LiDAR Quality Assurance (QA) Report  
Louisiana LiDAR ARRA Project - Region 2  
October 11, 2011

Submitted to:  
USGS

Prepared by:  
 **Dewberry**

<p><b><u>Contract:</u></b> Louisiana ARRA Region 2</p>	<p><b><u>Production Contractor:</u></b> Woolpert Inc.</p>	<p><b><u>Date Prepared:</u></b> 10/11/2011</p>	<p><b><u>Delivery #:</u></b> 3</p>	<p><b><u>Dewberry Recommendation:</u></b> Accept</p>
<p><b><u>Data History:</u></b></p> <ul style="list-style-type: none"> <li>• 1st delivery June, 2011.</li> <li>• 2nd delivery arrived September, 2011.</li> <li>• 3<sup>rd</sup> delivery arrived October, 2011.</li> </ul>

Figure 4 – 1<sup>st</sup> delivery. Ground density model of tile 16RBT715130 showing areas of red where points are removed from the ground model.

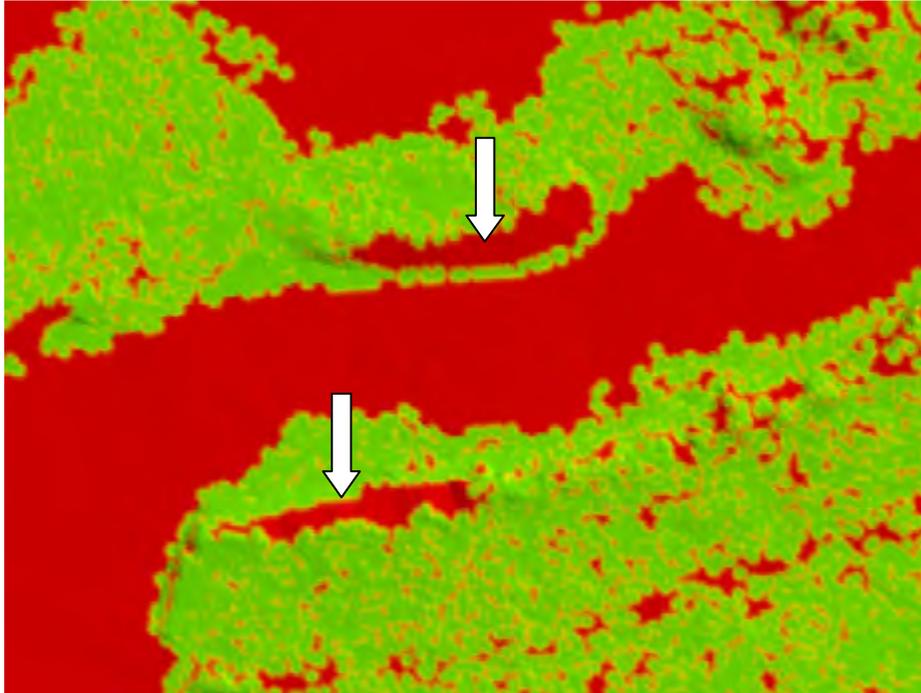
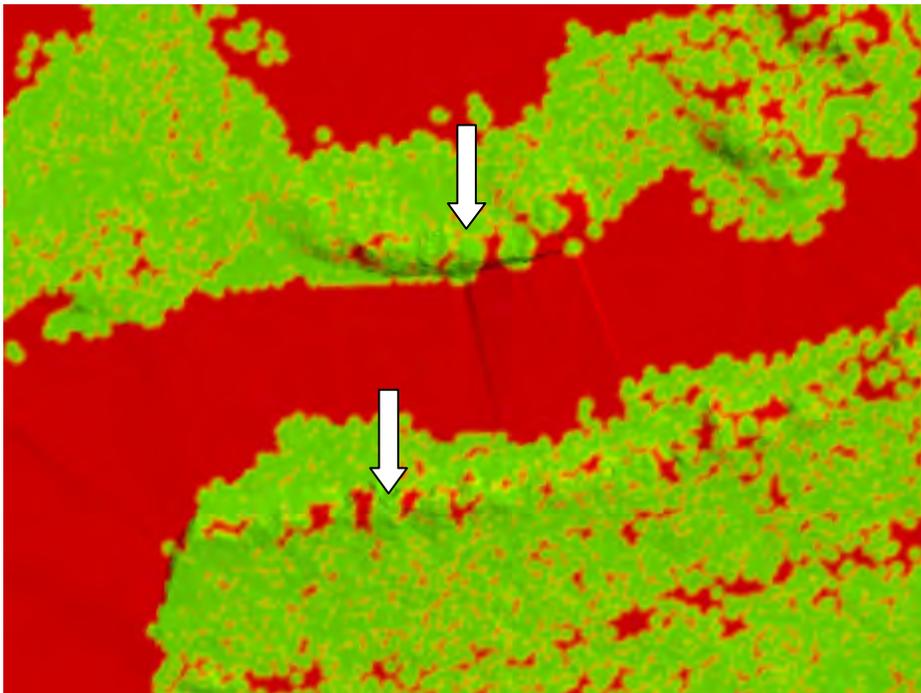
Misclassification calls in this document imply that LiDAR points are unclassified in the delivered dataset when they should be classified to ground. In other words, this call indicates that points that are unclassified (Class 1) should be moved to the ground (Class 2). One specific type of misclassification call is aggressive classification. This occurs when too many ground points are removed from the ground resulting in a loss of definition to the surface. This predominantly occurs along ridge tops or where there are significant changes in slope. Misclassification in the data was adequately corrected in the second delivery. Two examples of these calls and their corrections can be found below from Figure 4 to Figure 7.

Figure 5 – 2<sup>nd</sup> delivery - corrected. Tile 16RBT715130, second delivery. As many ground points as possible were moved from unclassified into ground class. The ground density model displays significantly less red in the marked features and is a better depiction of the true ground surface.

*Figure 12 - Ground density model of tile 16RBU550480. The areas of red in this tile are data voids.*

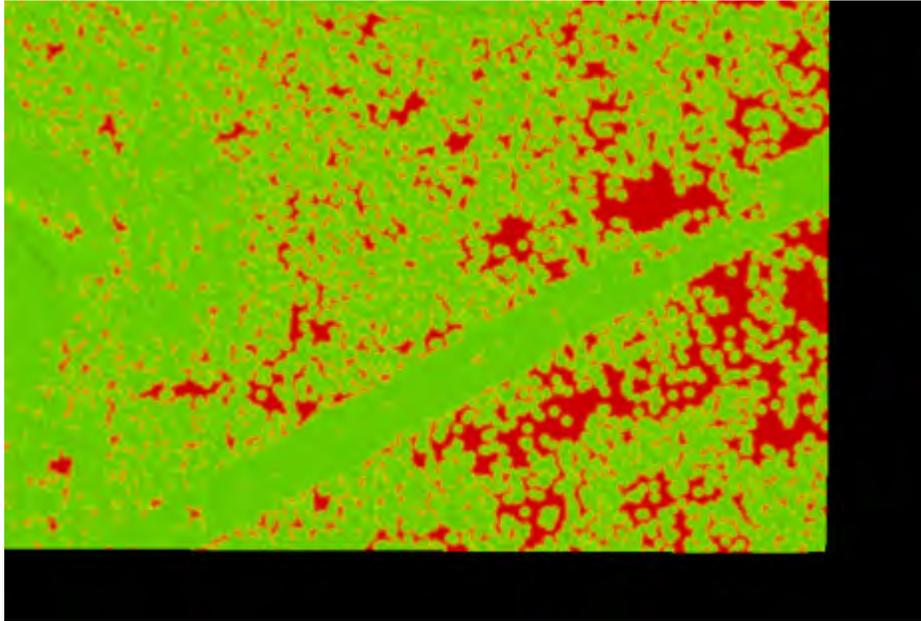
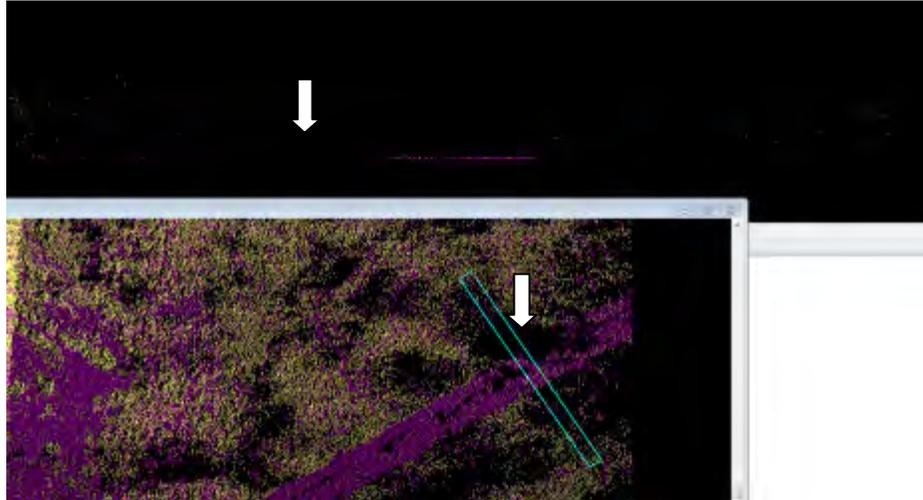
Data voids were identified in two areas resulting in 7 original calls. The voids seem to be related to areas where the intensity values are very dark (Figure 13). This error involves an anomaly with the LiDAR collection process. As seen in Figure 14 (the full LAS point cloud) no points were collected in the void areas. It would be costly and inefficient to fully correct for the void areas as the location would most likely need to be re-flown. Woolpert was unable to further correct the pictured tile below in the second delivery. However, Dewberry feels that because the voids are not widespread and are not of concerning size, they do not significantly impact the ground model. The void areas should be noted by the user but do not jeopardize the ground model or other LiDAR products.

Figure 14 - Full point cloud image of tile 16RBU550480 colored by classification. The profile and map view both show the data voids.

Figure 15 – 1<sup>st</sup> delivery. Ground density model of tiles 16RBT775265 and 16RBT775280 showing inconsistent editing between tiles. The tile on the right is more aggressively classified than the tile on the left.

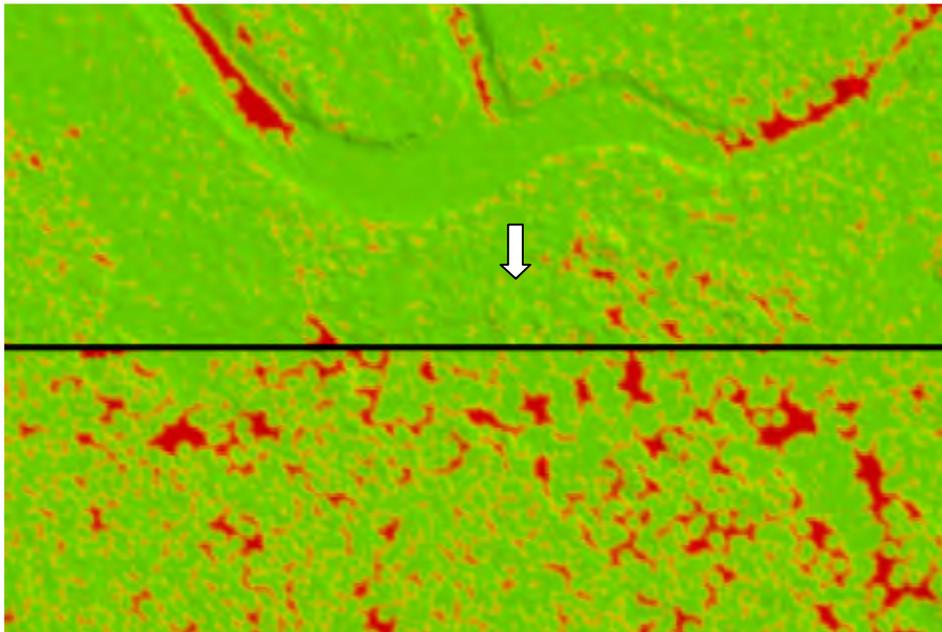
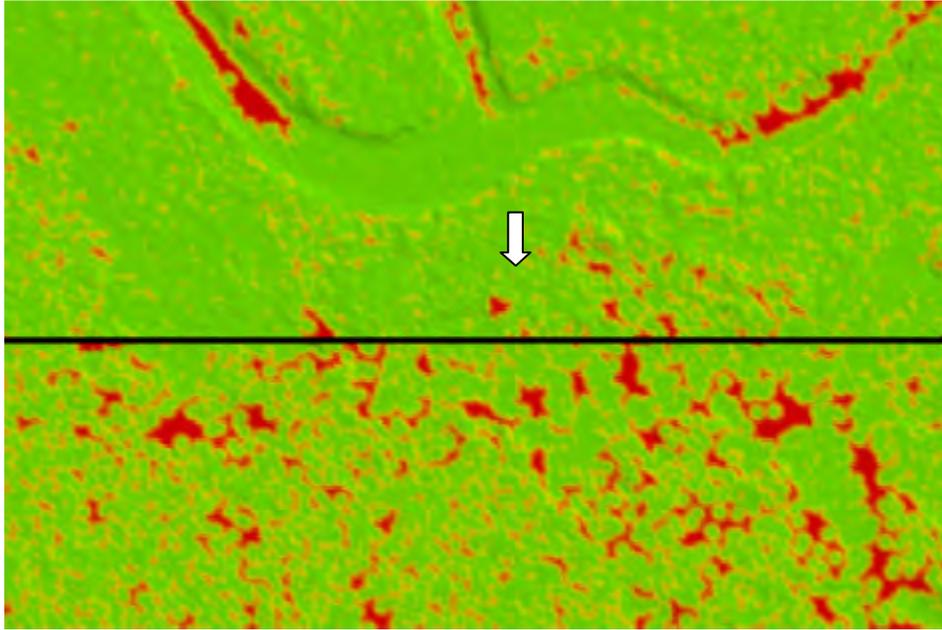
Inconsistent editing occurs only along boundaries between tiles. In these areas, the same automated-classification routine was not applied consistently to the same feature or different LiDAR classification analysts interpreted the feature differently (Figure 15 and Figure 16). Calls were placed on the tile that required editing. These issues were addressed in the 2<sup>nd</sup> delivery.

*Figure 16 – 2<sup>nd</sup> delivery - corrected. Ground density model of tiles 16RBT775265 and 16RBT775280, second delivery. A moderate amount of artifact points were removed from the area shown by the arrow making the tiles more consistent.*

Figure 17 - Yellow dots show tiles that Dewberry recommends Woolpert deliver to ensure there is no ground.

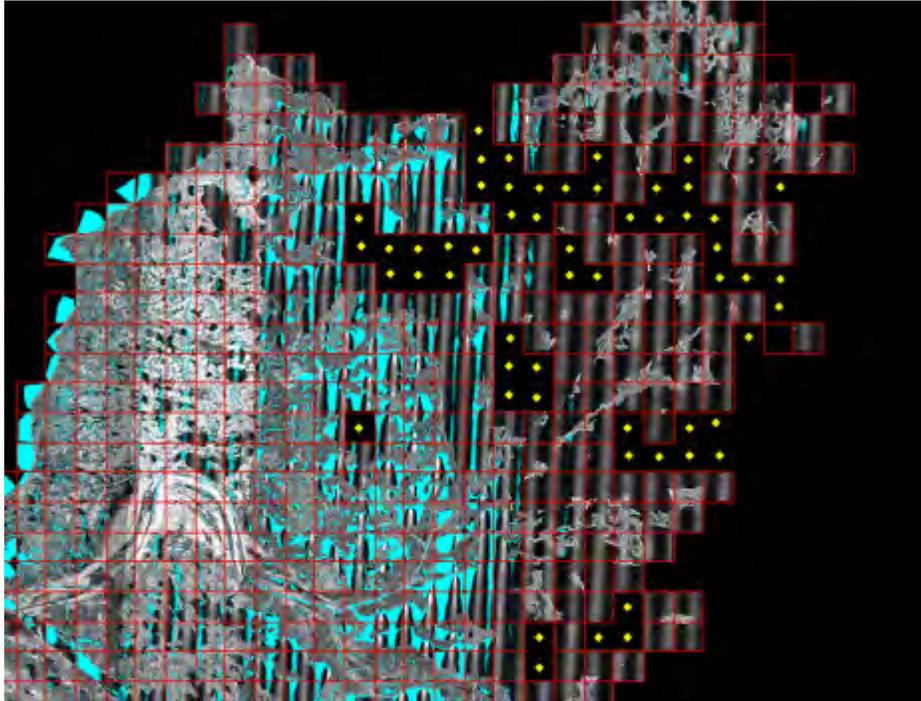
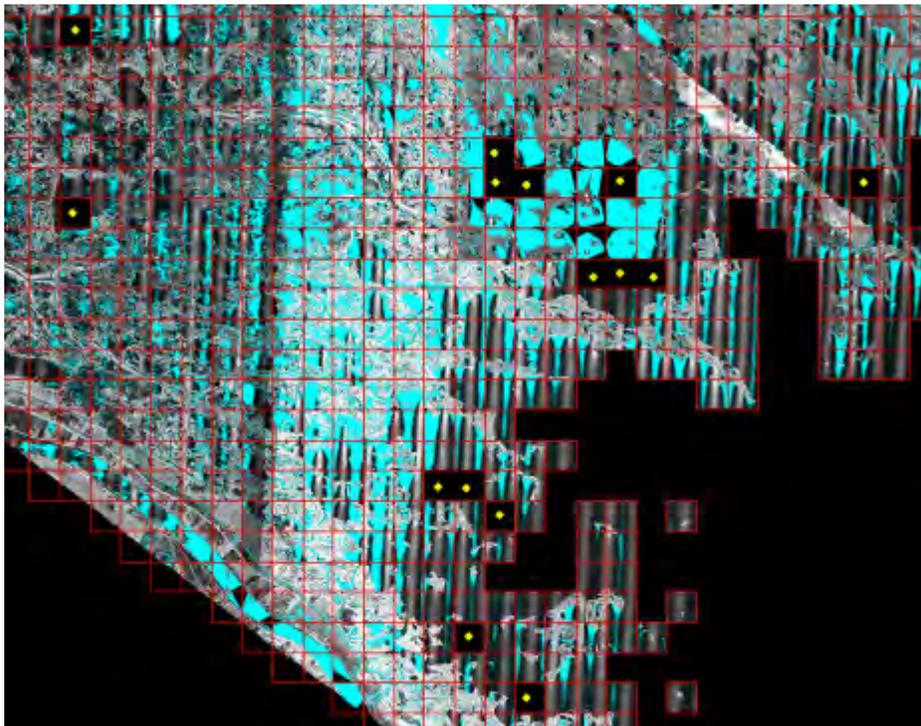
The data delivered to Dewberry in the first delivery appeared to be missing 74 tiles. Dewberry assumes all these tiles were not delivered because they Woolpert believed they contained no ground (i.e. are entirely water). Dewberry recommended that Woolpert send these tiles any subsequent deliveries so that Dewberry can confirm these tiles do not contain ground that is misclassified.

Figure 18 - Yellow dots show tiles that Dewberry recommends Woolpert deliver to ensure there is no ground.

Dewberry received the 74 additional LAS tiles and reviewed full point cloud models of each to assure no ground was overlooked. No ground which meets the requirements of being above zero elevation and greater than one half acre if an island was observed. It should be noted that significant amount of

Figure 21- 1<sup>st</sup> delivery. Ground elevation model of tile 16RBT520940 showing a ~20 cm flight line ridge.

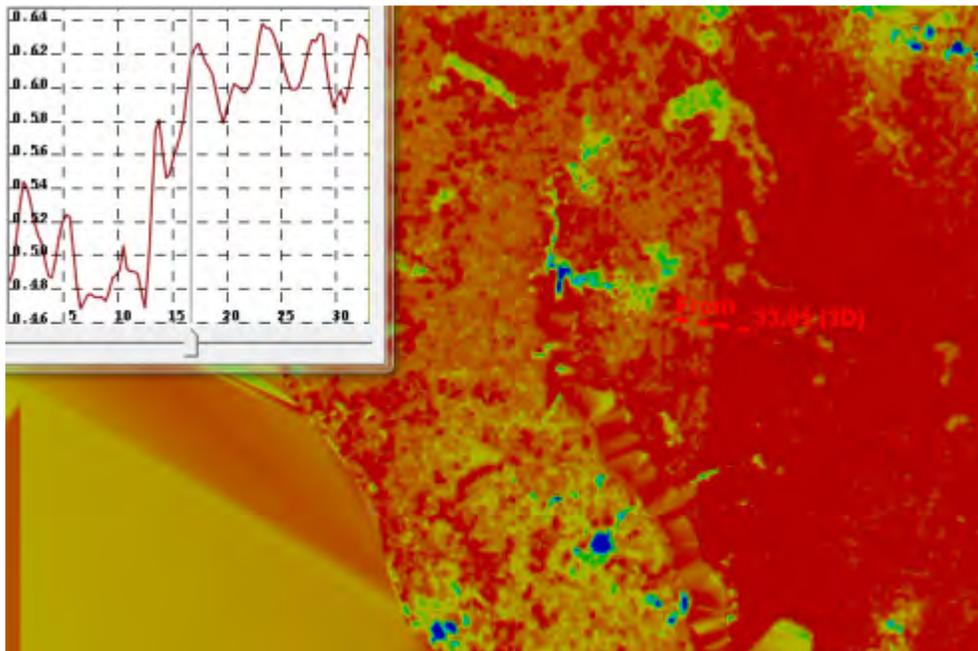
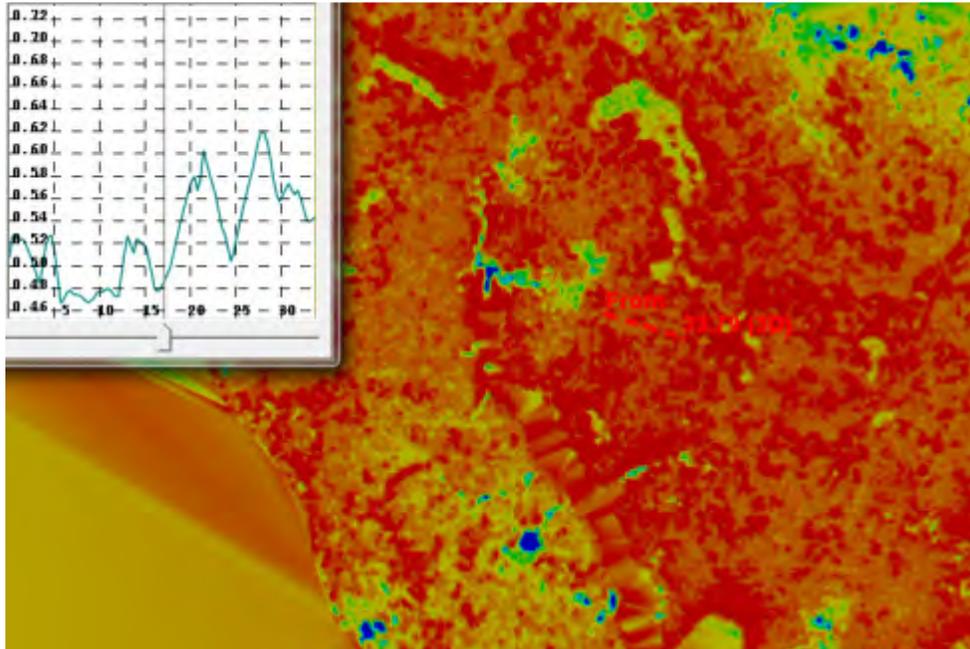
Several flight line ridges were originally identified in the Louisiana Region 2 LiDAR dataset. The ridges are caused by a vertical mismatch between two adjacent flight lines. Elevation differences along adjoining flight lines range from 10 cm up to 50 cm. Figure 21 and Figure 22 show a flight line ridge before and after corrections. The scope of work indicates that the acceptable criterion for flightline ridges is 10 cm. Dewberry provided a polygon shapefile that delineates areas that exceed project specifications for flight line ridges. The majority of the flight line ridges were adequately corrected by Woolpert for the second delivery. Three flight line ridges ranging from 10 to 30 cm were not fully corrected and are still visible in ground models of tiles 16RBT340940, 16RBT445595 and 16RBU220045. While over the specification of 10 cm, these remaining ridges are localized and overall the data meets project specifications.

Figure 22 – 2<sup>nd</sup> delivery - corrected. Ground elevation model of tile 16RBT520940, second delivery. The flight line ridge has been corrected.

Figure 24- 2<sup>nd</sup> delivery - Corrected. Full point cloud intensity image of tile 16RBU190135 with the second delivery breaklines. The two blue lines delineate a stream breakline. The islands breakline has now been correctly clipped to the streams breakline.

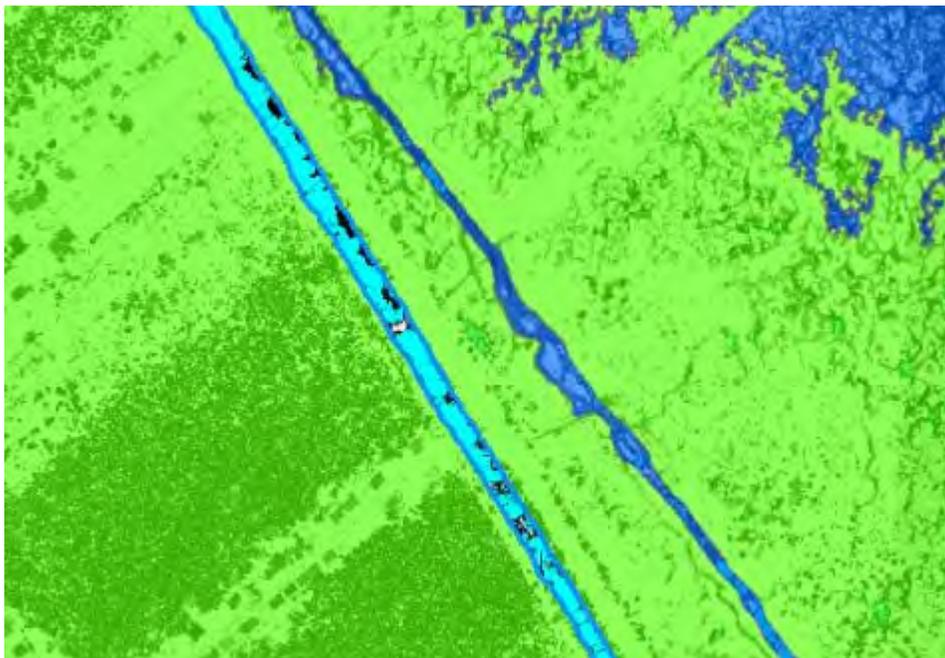
In the first delivery, the islands breaklines were not clipped at the extent of the streams breakline. This issue was fixed in the second breakline delivery. An example of the error and its correction is below in Figure 23 and Figure 24.

Figure 23 – 1<sup>st</sup> delivery. Full point cloud intensity image of tile 16RBU190135. The green area is the islands breakline and the two blue lines delineate a stream breakline. The islands should be clipped at the stream lines.

Figure 29 – 1<sup>st</sup> delivery. Ground elevation DEM of tiles 16RBU250150 and 16RBU250135 showing an area that contains no ground data. As evident below the points are classified as water when they are actually ground.

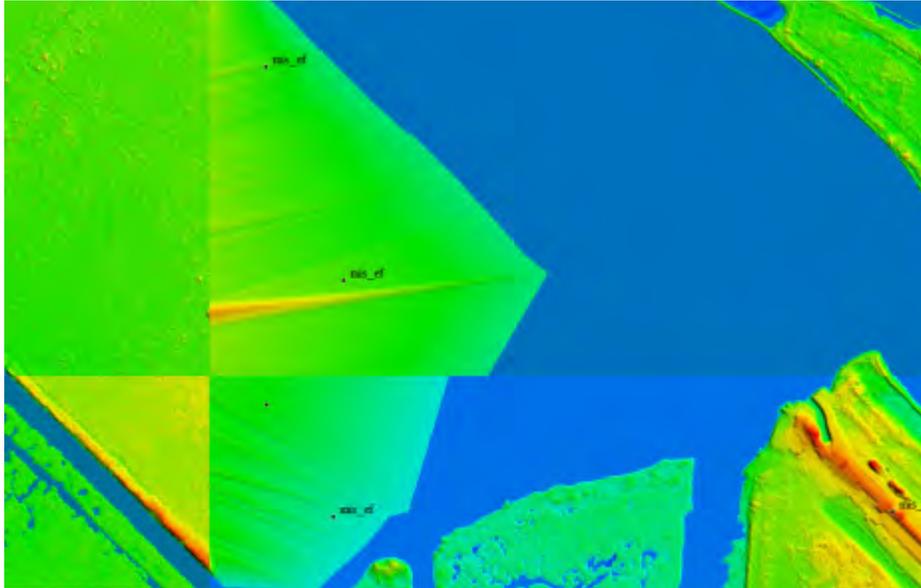
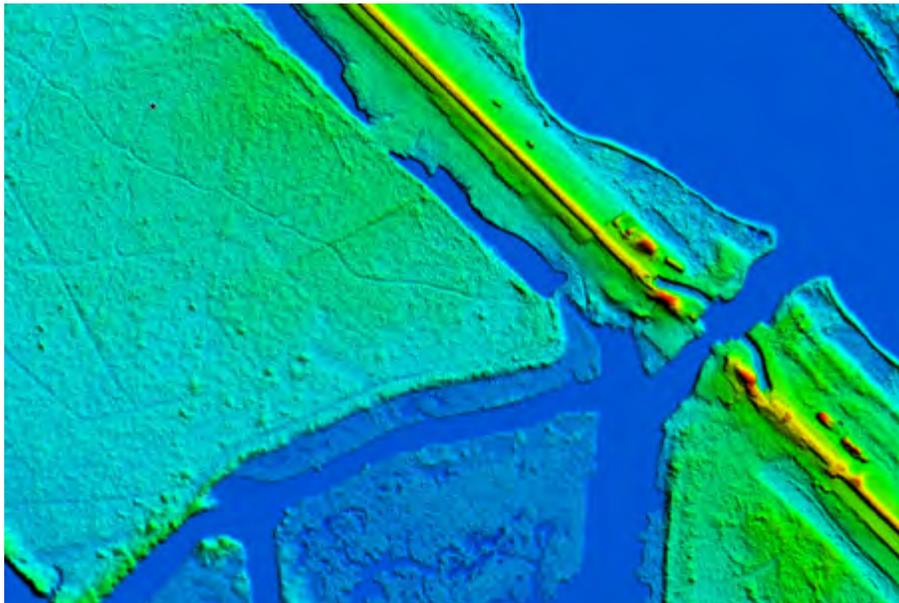
One serious issue was identified in the first delivery where ground points are classified to Class 9 (water). Issues with the data used to classify the points could cause ground, which was correctly identified during the breakline review, to be moved to Class 9. The issue and its correction in the second delivery are shown below.

Figure 30 – 2<sup>nd</sup> delivery - Corrected. Ground elevation of DEM of tiles RBU250150 and RBU250135 showing that the ground has been correctly classified and added back to the ground model.
